AGREEMENT

WHEREAS, the CRA desires to retain the services of the Contractor to provide the goods and services in accordance with the CRA's Invitation to Bid No. 2022-01-R, and the Contractor's response thereto, all of which are incorporated herein by reference.

ARTICLE 1. INCORPORATION OF INVITATION TO BID

7 FLOOR SLAB REINFORCEMENT LAYOUT NTS

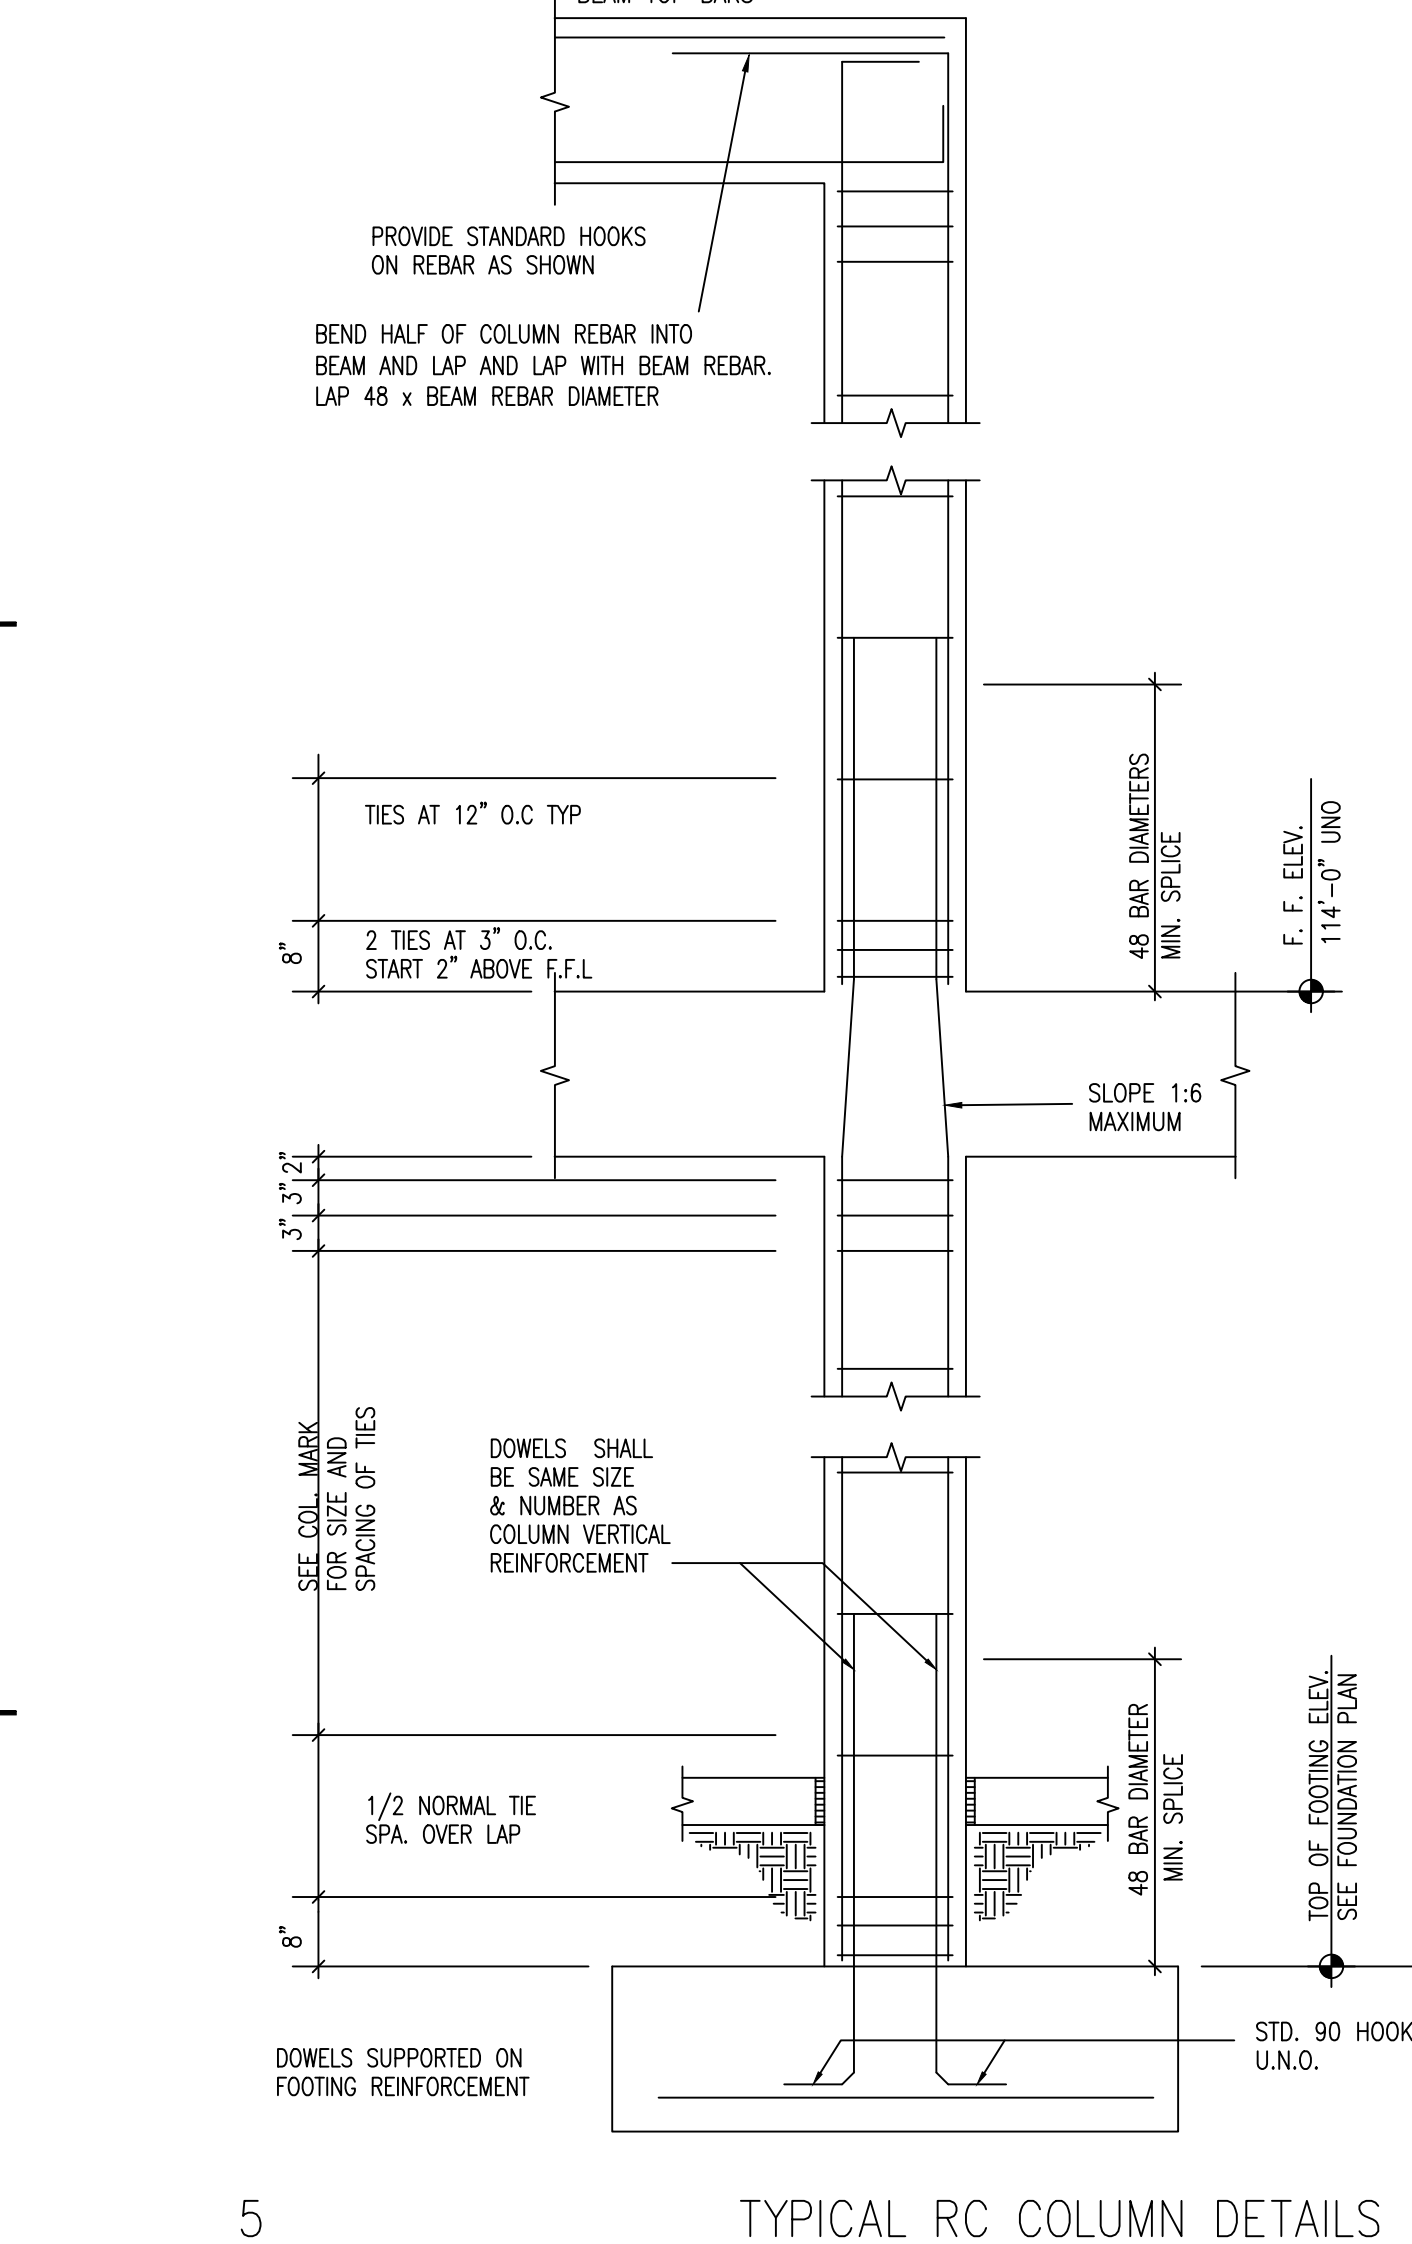
21. **2nd floor and roof framing plans, (Drawings S20 and S30) show a note of the slab with #3 at 12" OC, but on detail 7 (Drawing S22), it shows reinforcement with #4. Please clarify.**

Detail 7 (Drawing S22) revised. Drawing S22 is attached to this Addendum.

FLOOR FRAMING PLAN

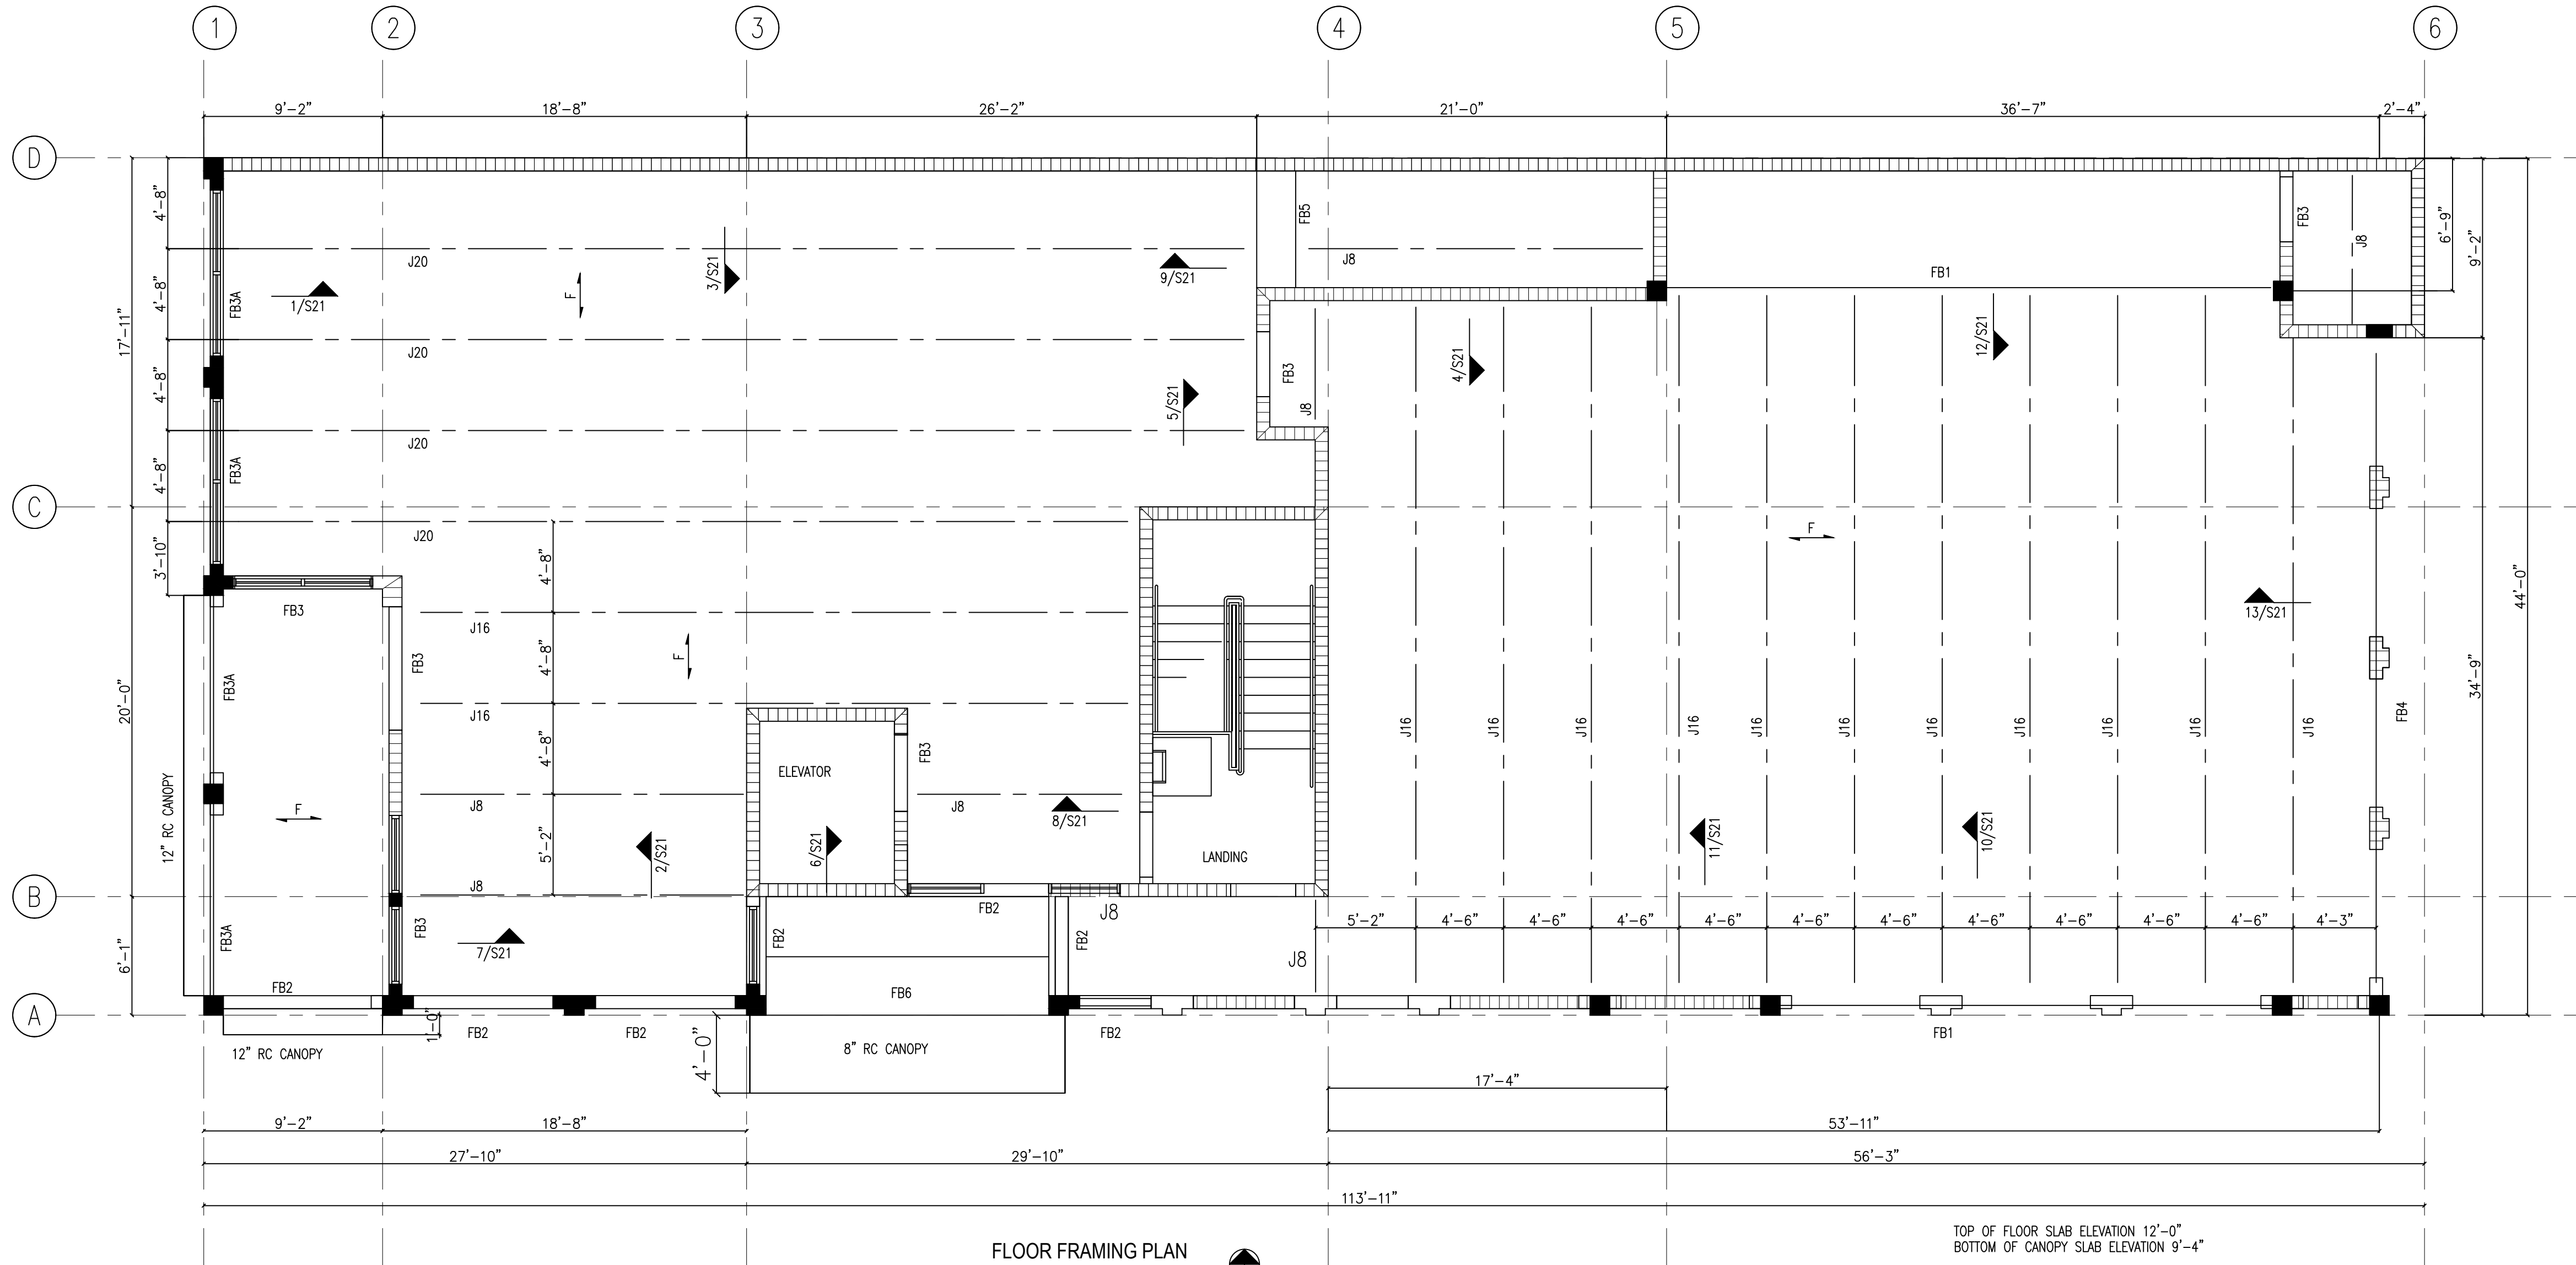
17. **FB1A shows on concrete beam schedule, but it does not show on the floor plan (Drawing S20), please clarify.**

23. **Drawing S20 does not show what kind of beam goes by schedule or will it be considered a couple bond beam. Please clarify.**

FB1A not used in the project. Drawing S20 is attached to this Addendum.

Use double bond beam unless FB shows on wall. Drawing S20 is attached to this Addendum.
